Memorandum

SUBJECT: **REGULATING PLAN WITH BUILDING WITH MAJOR WARRANTS FOR
A CONVENIENCE STORE WITH GAS SALES**

BACKGROUND: This is a request for approval of a regulating plan (concept plan) with major warrants for a convenience store with gas sales. The site is generally located at the northwest corner of HWY 5 and Stacy Road and is zoned for the (CPDD) Commercial Planned Development District with the Urban Village sub-district. Applicant: David Bond, Spiars Engineering representing Racetrac Petroleum, Inc. and owners Village FV, LTD.

**FUEL CANOPY
ELEVATIONS**

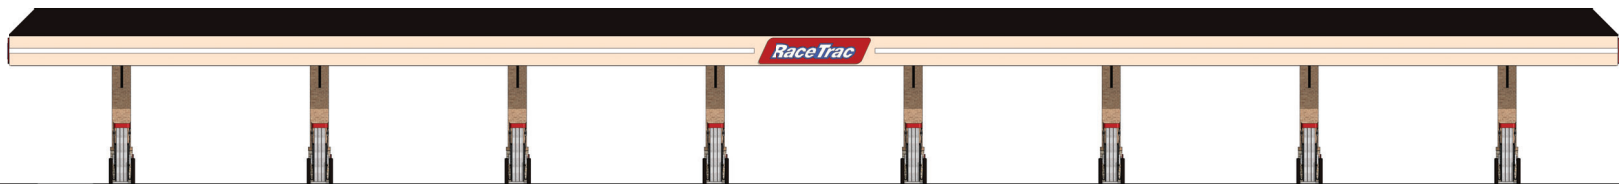
3	Canopy	Min 75%	North: 24% South 56% West: 0%	<p>Applicant: East: RaceTrac's proposed outdoor patio and seating are on this elevation. RaceTrac has provided a roofed-patio.</p> <p>West: While no awnings are provided on this elevation, additional façade rhythm elements above what are present on RaceTrac's prototypical building have been provided.</p> <p>North: While few awnings are provided on this elevation, additional façade rhythm elements above what are present on RaceTrac's prototypical building have been provided.</p> <p>South: The awnings that are provided on this elevation fit in with the aesthetic design of the building. Additional awnings would look out-of-place and, in RaceTrac's opinion, become detrimental to the overall look of the building.</p> <p>Staff: The intent of the canopy regulation is to provide covered walkway for pedestrians in an urban style setting. In this case, the north elevation corresponds with the utility, coolers, and kitchen area of the interior, and with no parking on this side of the building, no</p>

customers will be present. There is a sidewalk on the west side of the building, therefore, canopies should be present.
4	Signage (Sec. 6.4.10)	Electronic box sign, 9 feet tall 75 square feet	Internally lit 20 feet tall 100 square feet	<p>Applicant: A proposed Fairview Town Center (FTC) sign is being located at the intersection of Stacy and Greenville – by the request of the Town. The proposed location of this FTC sign was the preferred location for RaceTrac’s original proposed monument sign (8’ tall).</p> <p>In order to mitigate the visibility concerns resulting from this FTC sign, water tower, gas line infrastructure, and miscellaneous fencing, RaceTrac is proposing a 20’ tall monument sign.</p> <p>The sign will be composed of a large brick base with a sign cabinet on top. In order to screen the large expanse of brick base, additional landscaping is being provided around the sign.</p> <p>Finally, the proposed location of RaceTrac’s monument sign is setback approximately 180’ from the visible roadway.</p> <p>Staff: As a condition of approval of the revision of the agreement with the center, the Project and Town identity sign must be installed before a Certificate of Occupancy can be issued for this gas station. The Project and Town Identity Sign was approved as part of the Master Sign Plan by the new owners of the mall area, in 2017</p>

1. Site and canopy shall be development generally in accordance with the attached regulating plan exhibits including the following:
 - a. Covered seating area on the east side shall be extended to the front of the building around the southeast corner.
 - b. Faux or translucent (spandrel) windows with matching canopies shall be installed on the western façade.
 - c. Pump Canopy shall include:
 - i. Pitched roof design
 - ii. Masonry columns
 - iii. Recessed lighting
 - iv. Color pallet as presented
 - d. Outdoor storage and/or display of merchandise shall be prohibited.
